■Specification and Appearance Differences Due to Specification Changes

Type : CFUR／CFU

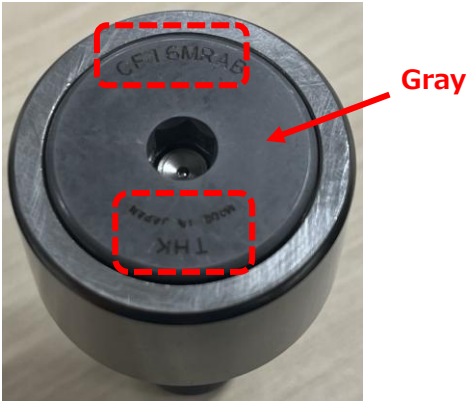
【Before Change】

Engraving : Manufacturer Part Number, Manufacturer Logo, Country of Origin

【After Change】

Engraving : MISUMI Part Number, MISUMI Logo
